Application Number 10/607,634
Amendment dated November 10, 2004
Reply to Office Action of August 13, 2004

Amendments to the Drawings:

FIG. 9

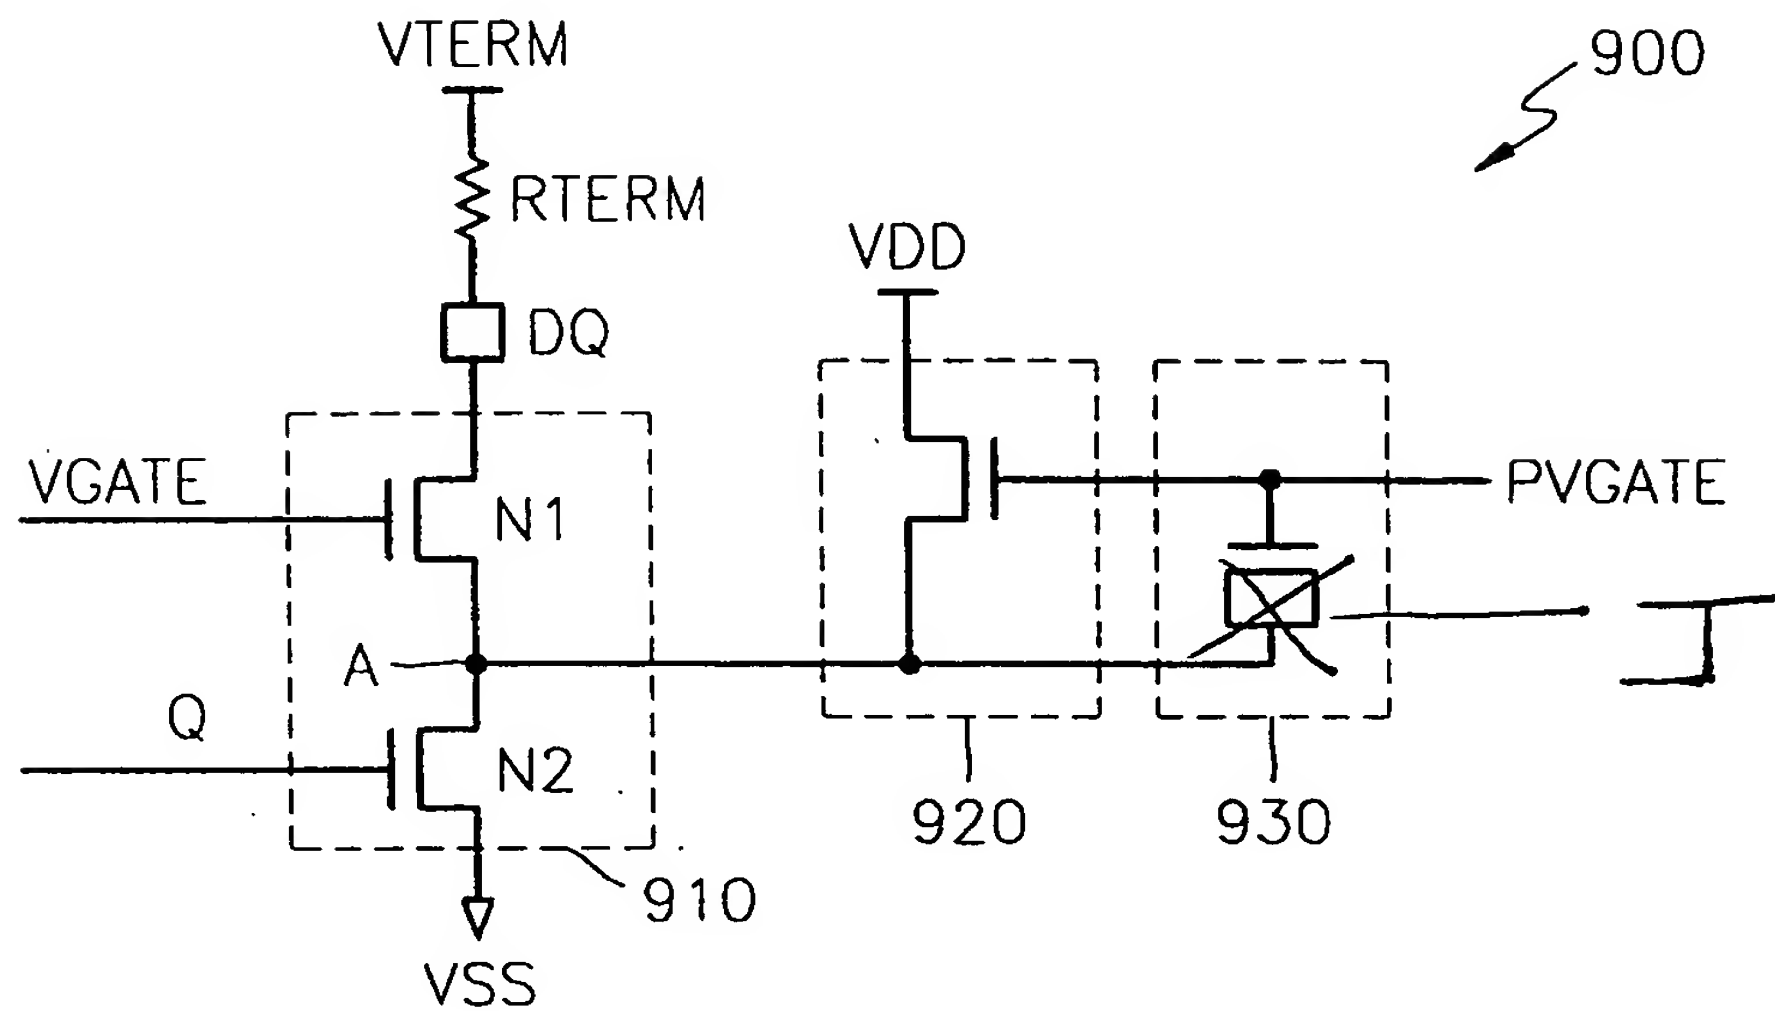
The drawings are objected to as not showing the capacitor set forth in claims 8 and 9. The drawings are further objected to as failing to show a capacitor as described in the specification. Figure 9 is amended herein to clearly illustrate the capacitor in one embodiment of the voltage compensating circuit 930 of the invention. The capacitor is described in the specification as filed at least at page 9, line 32 through page 10, line 2. Accordingly, the amendment to Figure 9 does not introduce new matter into the application.

The attached sheet of drawings includes changes to FIG. 9. The sheet, which includes FIGs. 9 and 10, replaces the original sheet. FIG. 9 is amended to illustrate the capacitor of the invention.
